Jason Deters  
Project Manager, California South Branch  
U.S. Army Corps of Engineers  
Sacramento District, Regulatory Division  
1325 J Street, Room 1350

Re: Response to Comments on the Hydrogen Energy California Wetland Delineation

This letter is provided on behalf of Hydrogen Energy California, LLC (HECA) to respond to your comments transmitted via e-mail on May 9, 2013. Responses to each comment are provided below and in the enclosed attachments.

Representative photograph showing the location of **DP 157**, facing northeast and downslope. This low-gradient swale lacks hydrophytic vegetation or hydric soil indicators. Only a single secondary hydrologic indicator (i.e., drainage pattern) was evident at this location.

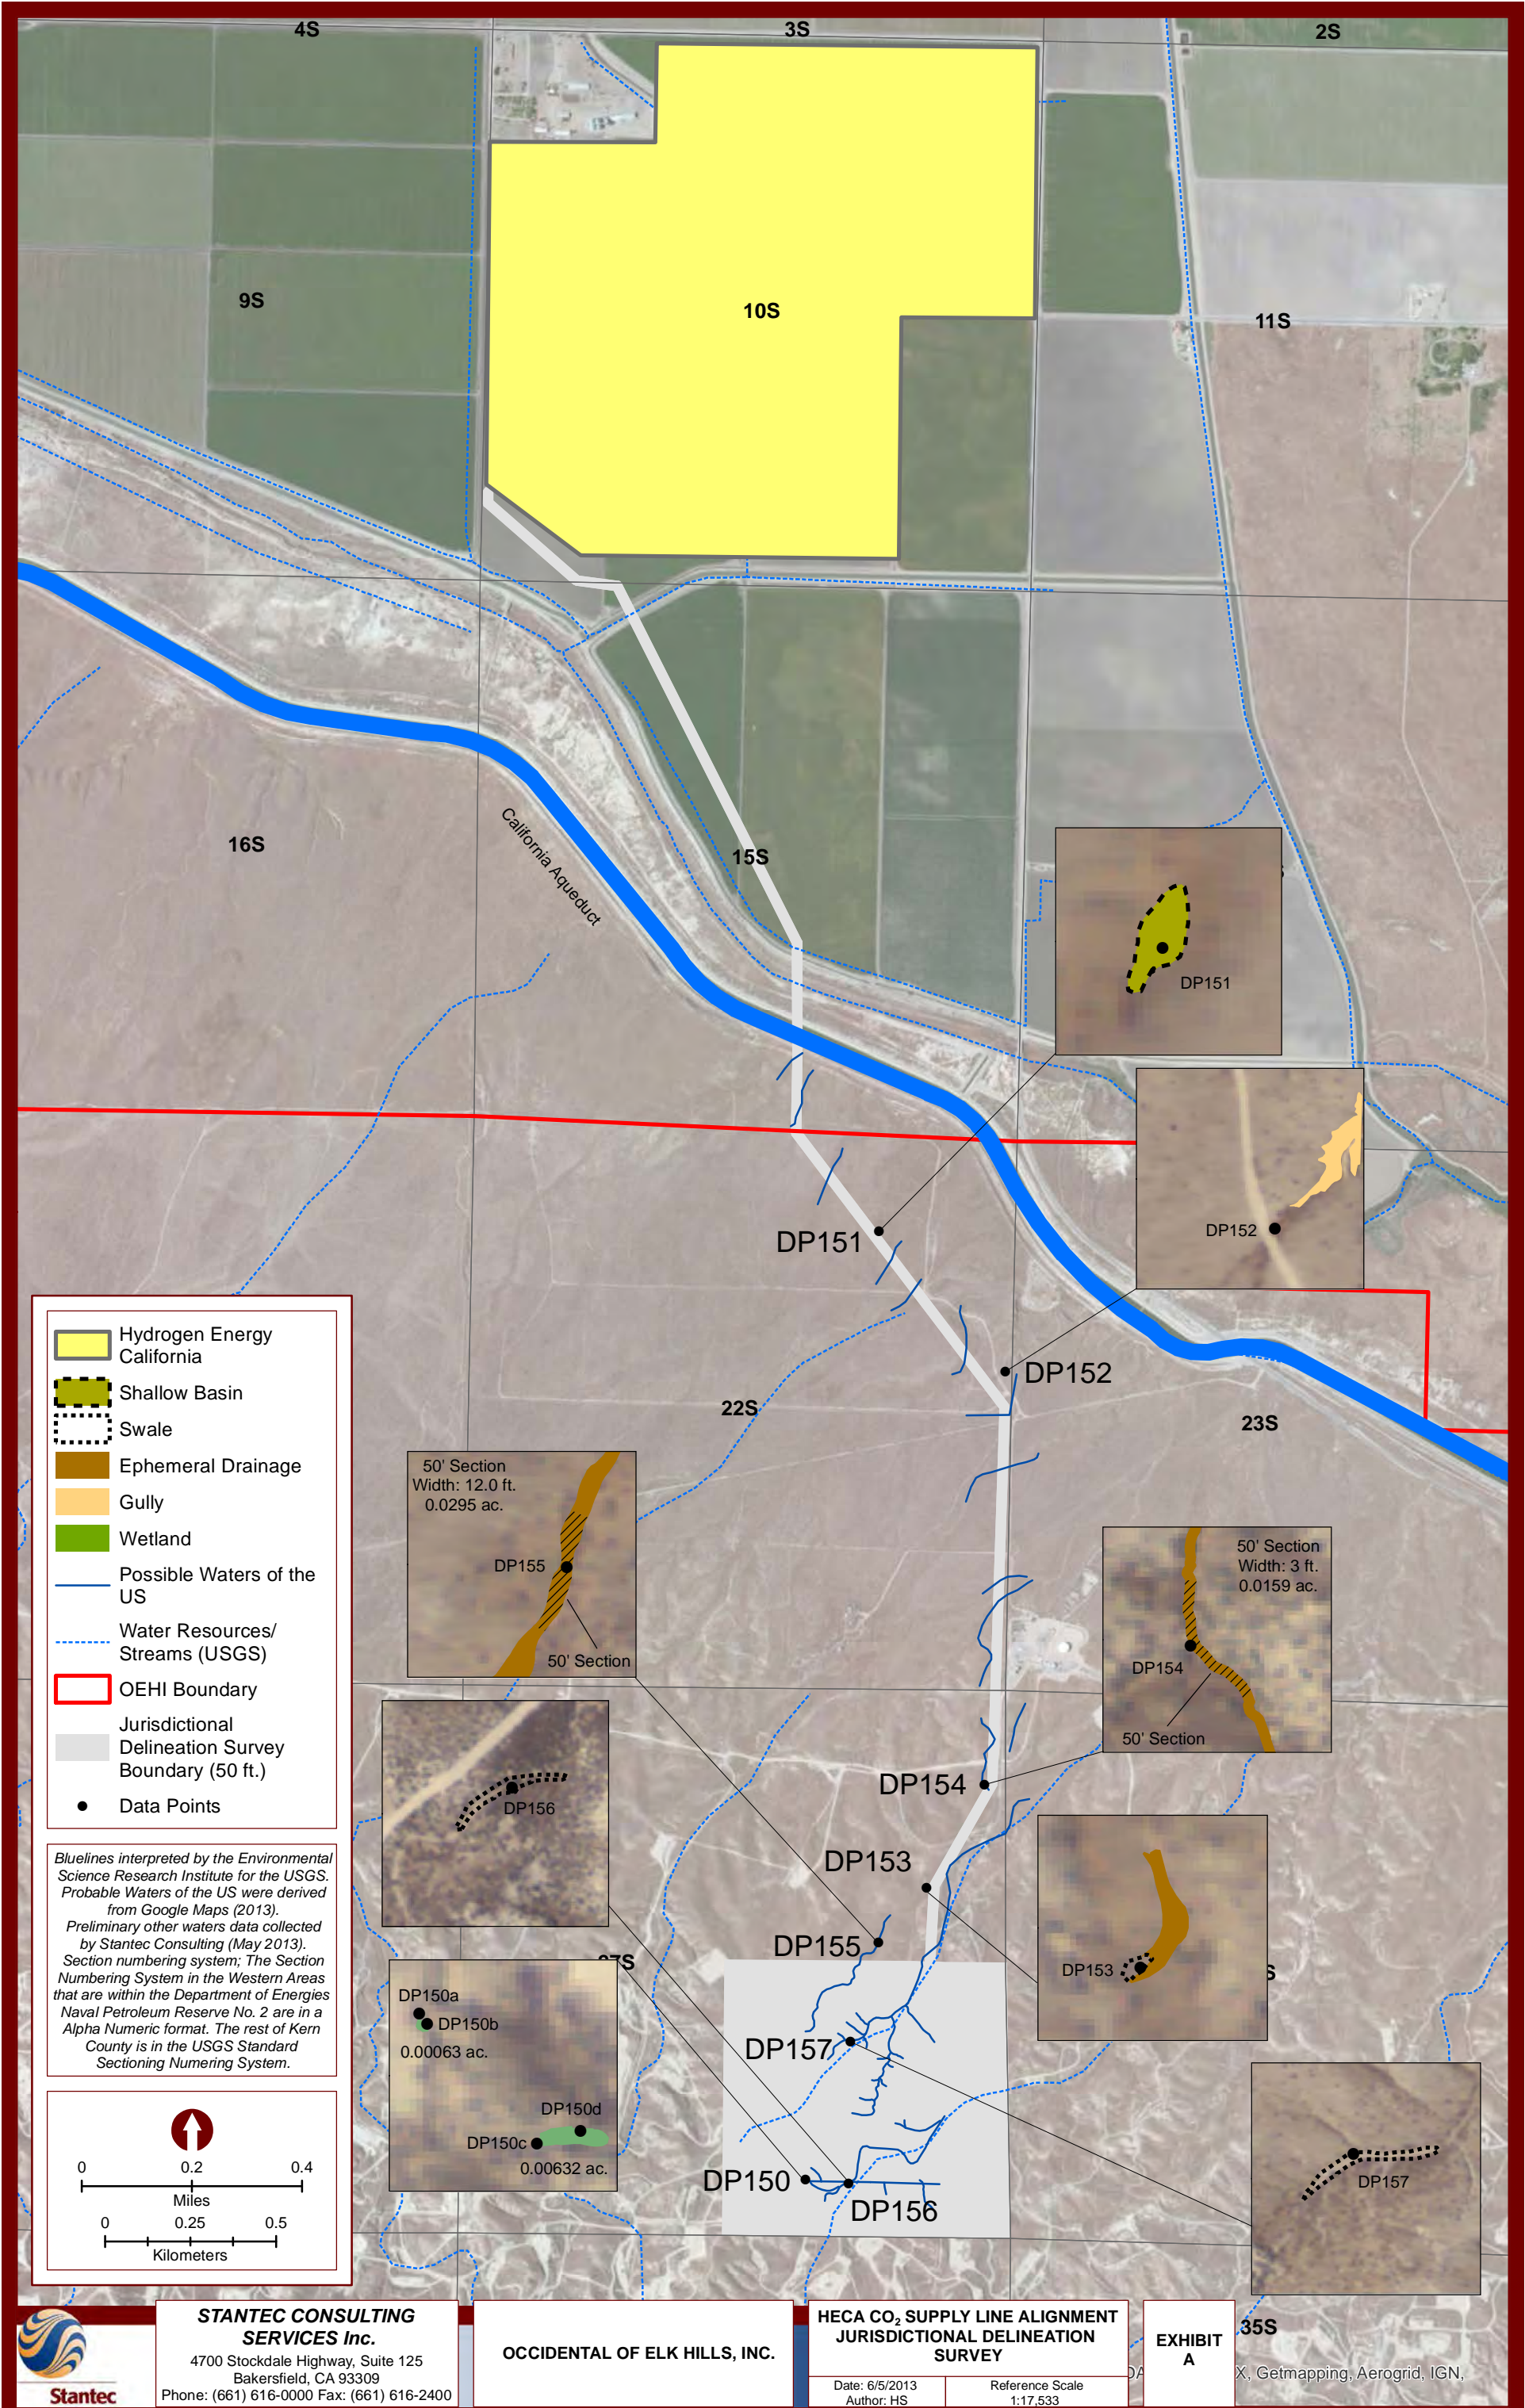
Representative photograph showing the location of **DP 156**, facing northeast. This low-gradient swale lacks hydrophytic vegetation or hydric soil indicators. Only a single secondary hydrologic indicator (i.e., drainage pattern) was evident at this feature.
